Derby Diocesan Association of Church Bellringers Consultant's Report	Report DDACB 12/05
Church of Saint Martin Alfreton – Inspection of Bells	Issue Date 22/11/05

FIGURE 1
Ringing Room

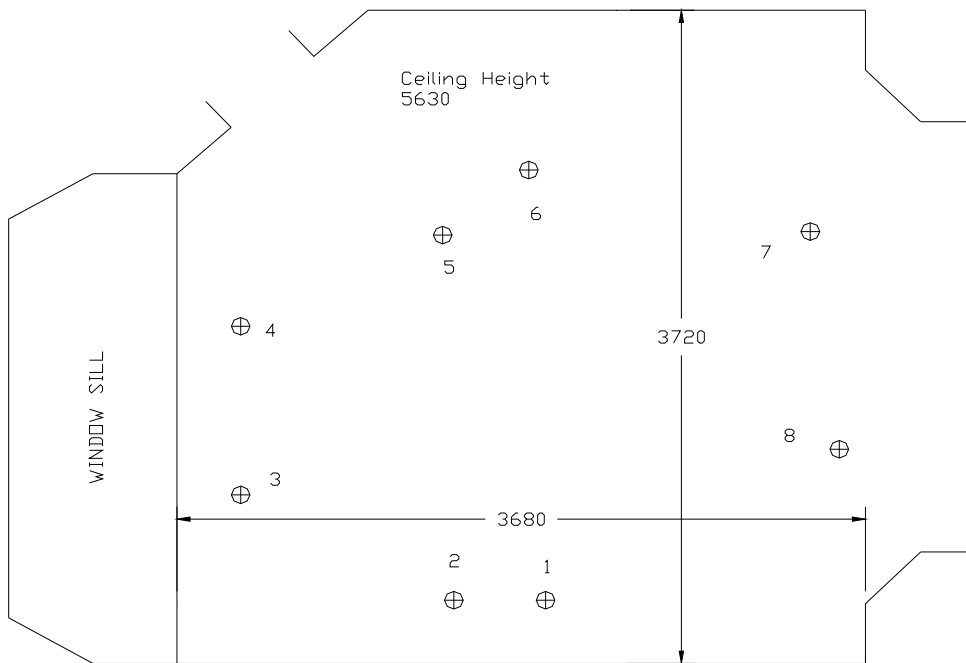
The centre of the room is dominated by a wooden clock pendulum case which extends through the ceiling and finishes 2.26 metres above the floor. Although intrusive, the pendulum case does not seem to seriously affect rope sight.

FIGURE 2
 Bell Chamber and Frames

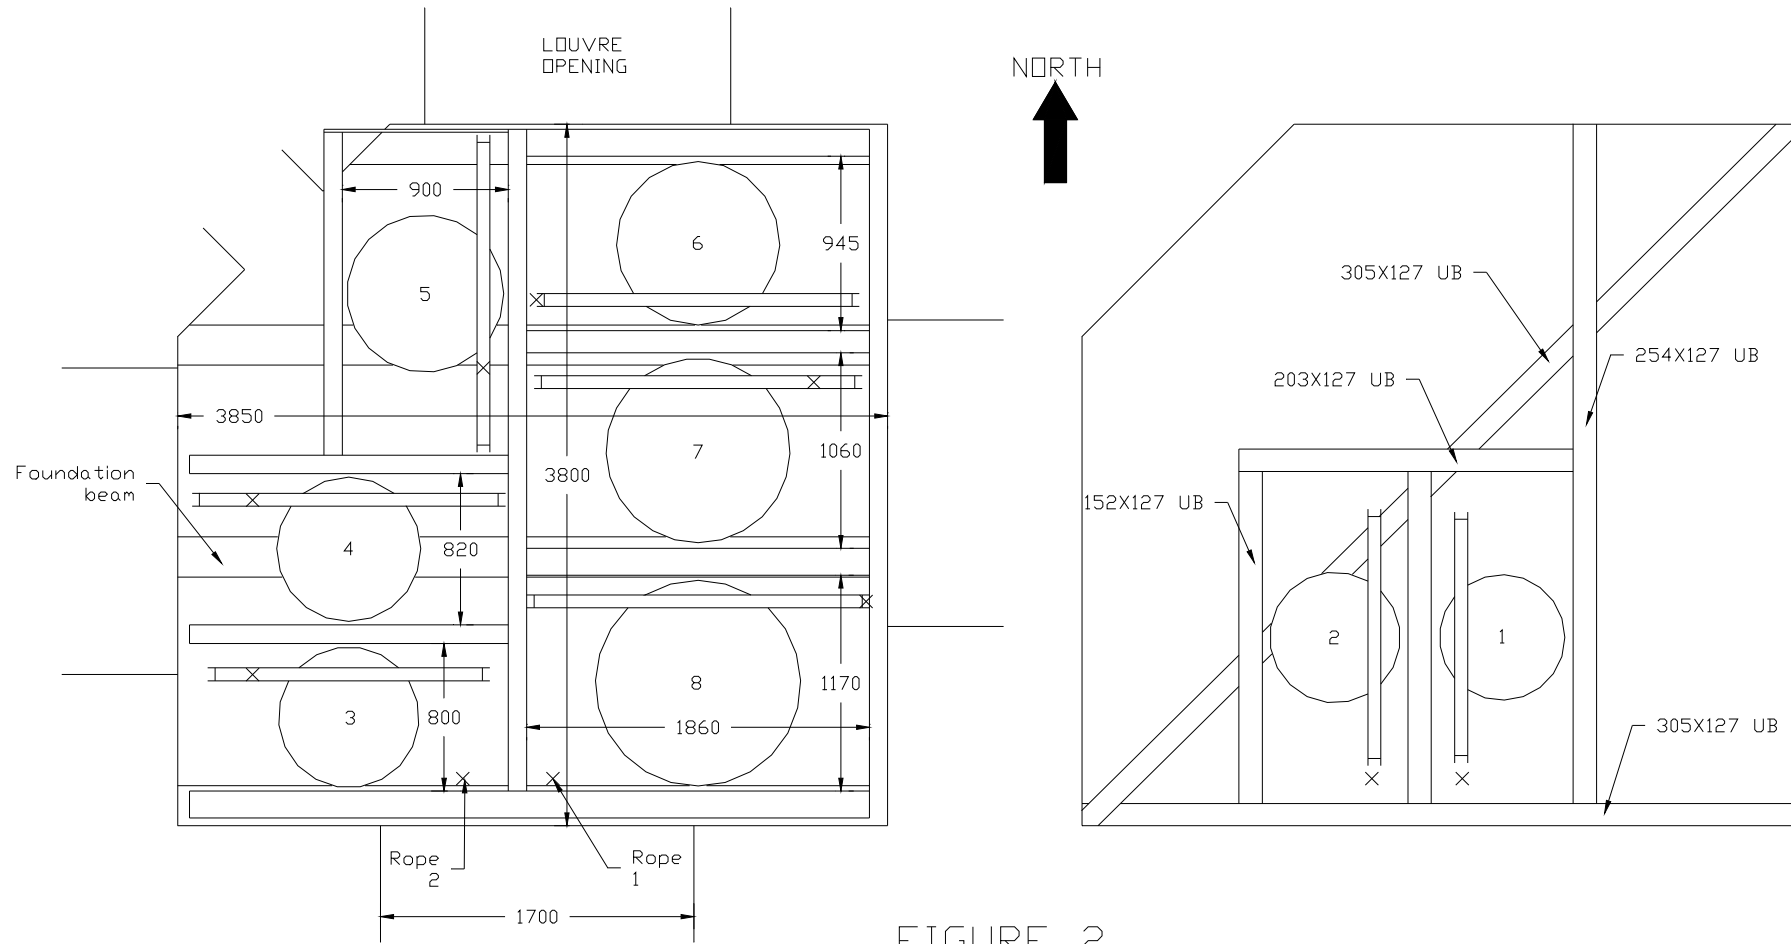
The bell chamber is reached by a further 29 steps. There are four louvre openings, one to each aspect of the tower and both natural and artificial lighting are adequate. Although there is metal mesh over the louvre openings it is not adequate to exclude birds as evidenced by considerable quantities of bird debris on the bell frame and floor. This debris retains moisture and promotes favourable conditions for the onset of rot in adjacent timbers. (It is also a health hazard). The debris should be removed and the louvre openings covered in "Galebreaker" porous sheeting.

The upper steel frame carries bells 1 and 2 and is supported by a 305X127 steel universal beam set diagonally across the bell chamber. All of the steel work has considerable surface corrosion, although it appears to be structurally sound.

The bottom frame, carrying the other six bells, is a low-sided frame of wooden construction which appears to be in good condition. Since there is limited space for the bells and frame, the pits in which bells 3,4,6,7 and 8 swing have gallows ends and the whole frame is set above the tower offsets noted in section 5.0. The frame sits on four 350X200 wooden foundation beams, which are set east/west, and the top of the frame is roughly level with the louvre sills resulting in all bells being above the sill height. When heard from outside the church this results in some bells appearing louder than others dependent on which louvre is closest to the observer. (Ideally all bells should be below sill level to give an even sound at all compass points outside the church). None of the bells was rung to assess frame movement but it was considered that any movement would be acceptable given the good state of the frame. If any looseness were found in the frame, tightening of the metal frame ties would reduce it.

FIGURE 3
Possible arrangement
of existing bells in
single level "H" frame
(subject to confirmation
of professional bell
hanger)

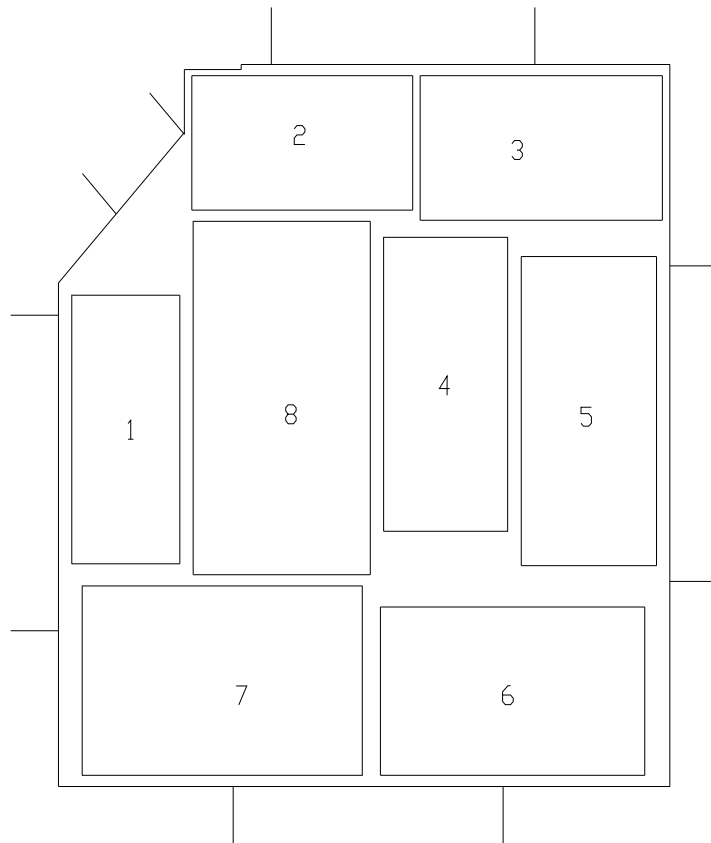
- Install the retuned bells at a single level (with new fittings) in a new metal "H" frame set at the same level as the existing wooden frame. Figure 3 shows that this may be feasible (the width of each rectangle is the bell diameter and the length is the wheel diameter) however this will need to be confirmed by a professional bell hanger.
- If the above is not possible, install bells 3,4,5,6,7 and 8 with new fittings in a new metal frame lower down the tower and refurbish the existing steel frame and fittings for bells 1 and 2. The clock would be reinstalled
